**NEW MEXICO OIL CONSERVATION DIVISION**  
 - Engineering Bureau -  
 1220 South St. Francis Drive, Santa Fe, NM 87505

Poker Lake UNIT  
#71A

**APPLICATION FOR AUTHORIZATION TO INJECT**

**EDDY COUNTY, NEW MEXICO – NASH DRAW (DELAWARE) FIELD  
POKER LAKE UNIT #71A – API #30-015-26084**

## TEMPERATURE SURVEY REPORT

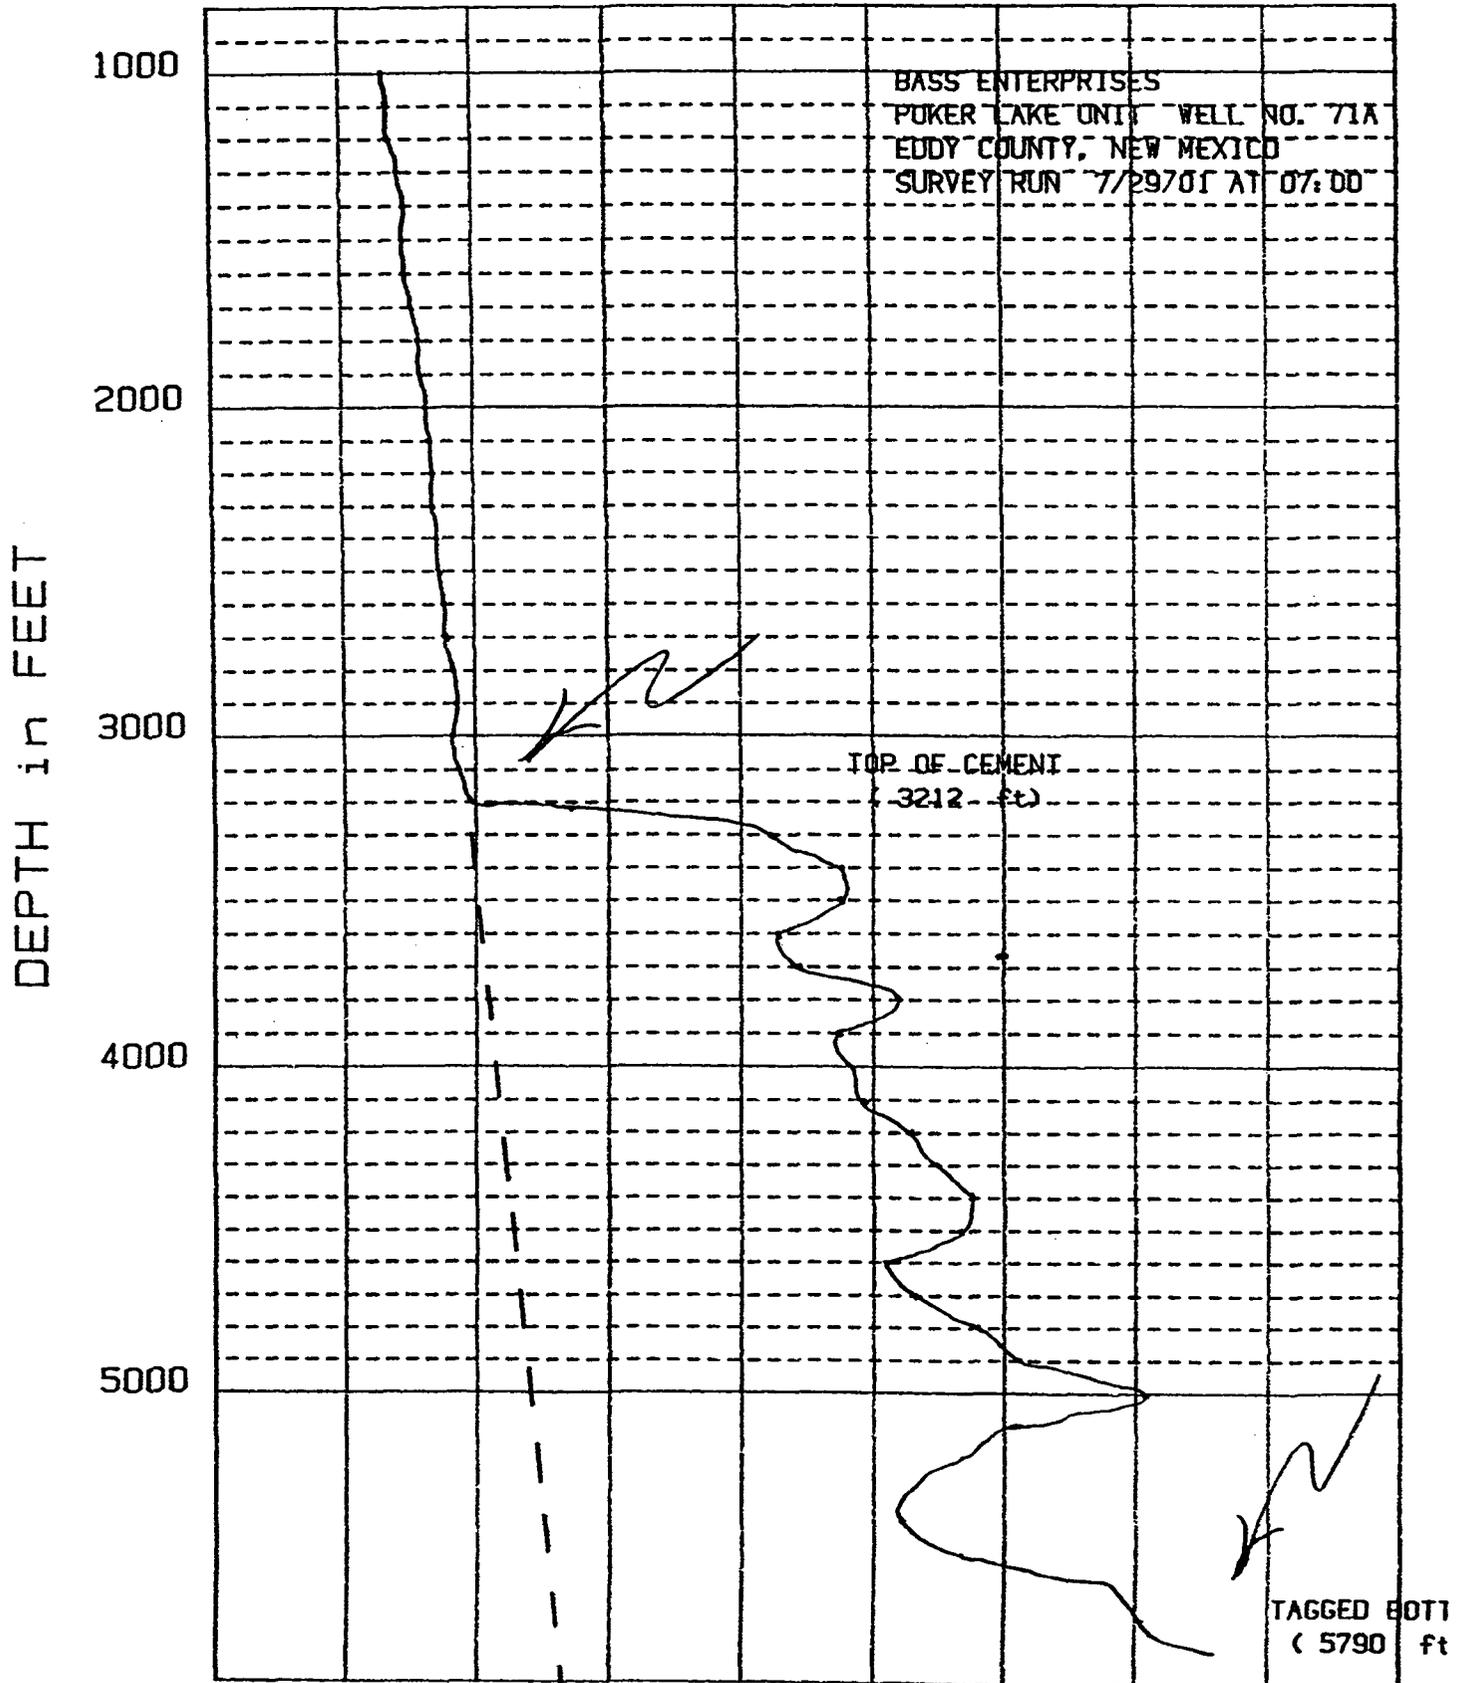
- 1) How was the 3,450 top of cement determined? Send a copy of the bond log or temperature survey along with the application, and also send this to the Artesia office, since they do not have a copy.

What I would do is go ahead and have Bass obtain a waiver from the potash lease holder. I would also have Bass submit to you how they determined the TOC for the production string. This would be either a bond log or an estimated calculation of determining the TOC or a temperature survey. I cannot find any of this data.

07-30-01      Ran temperature survey & found TOC @ 3212'

LEASE: PO...R LAKE UNIT

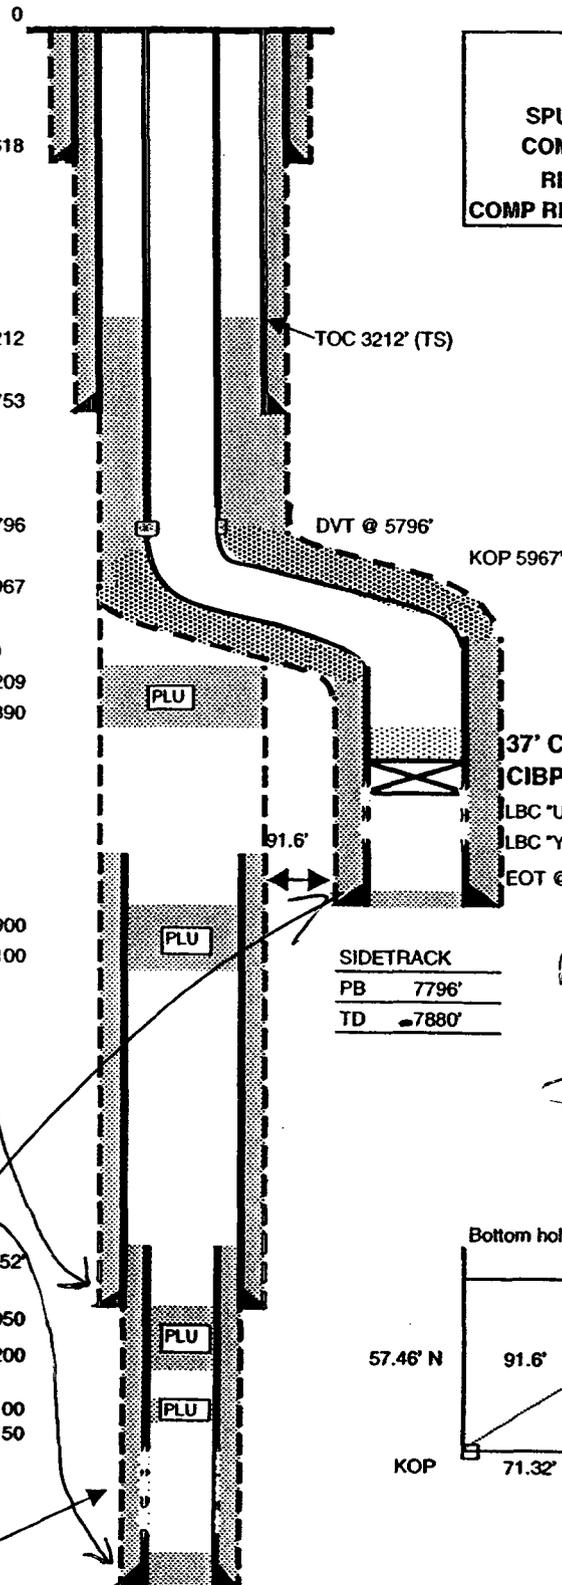
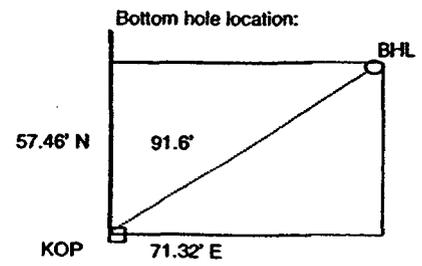
- 1) Please re-run your newspaper notice with the correct NMOCD address. Send me evidence the new newspaper notice was run and the date it was run.
- 2) Please do a "before conversion" well bore diagram and send it to me.
- 3) What is the bottom hole location? Is it the same as the surface location? (This well is sidetracked)
